**SERVICE BULLETIN No. 1123C**

**SUBJECT: PA-34 SERIES AIRCRAFT NOSE GEAR INSPECTION AND PRODUCT IMPROVEMENTS**

**REASON FOR REVISION:** SB 1123C expands serial numbers affected to include all PA-34 airplanes. Additional changes have been made to clarify fastener hardware inspection / replacement requirements and to bring inspection requirements up-to-date with respect to changes which have been made in the PA-34 maintenance manuals.

**Figure 1**  
[Trunnion Inspection](#)  
[\(See Table 1, Item 3\)](#)

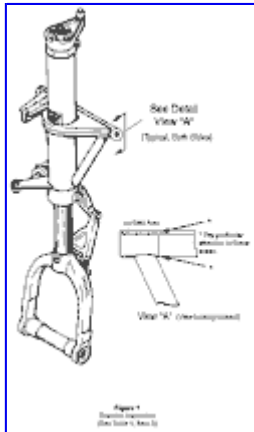
3.	Visually inspect (2000 hrs. initial) the nose gear trunnion (P/N 95723-00, -05, -06) for cracks in the area of attachment to the nose gear mount assembly (See <a href="#">Figure 1</a> ) using supplemental lighting and a 10X magnifier				0

**Figure 2**  
[Service Wear Limit Locations](#)

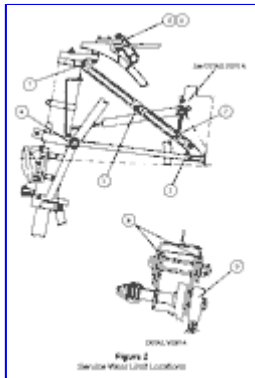
[Table 3](#) is a "Wear Limits Chart" that can be used to determine the acceptable / or replacement condition for the listed parts that were inspected per Instructions [Step 1](#). in this Service Bulletin. Visually inspect all bolts/pins for wear, damage, or corrosion. Replace as required.

Part Description		ID Wear Limits		Part Description		ID Wear Limits	
		Min.	Max.			Min.	Max.
1.	Drag Link Upper Bushing	0.562	0.564	6.	Steering Arm Center Pivot Sleeve	0.250	0.253
2.	Drag Link Center Bushing	0.375	0.377	7.	Down Lock Link Bushing	0.251	0.253
3.	Drag Link Lower Bushing	0.438	0.442	8.	Actuator Mount Bracket	0.250	0.252
4.	Trunnion Pivot Bushings	0.500	0.503	9.	Down Lock Link Rod End	0.190	0.192
5.	Steering Arm Center Pivot Bushings	0.375	0.377
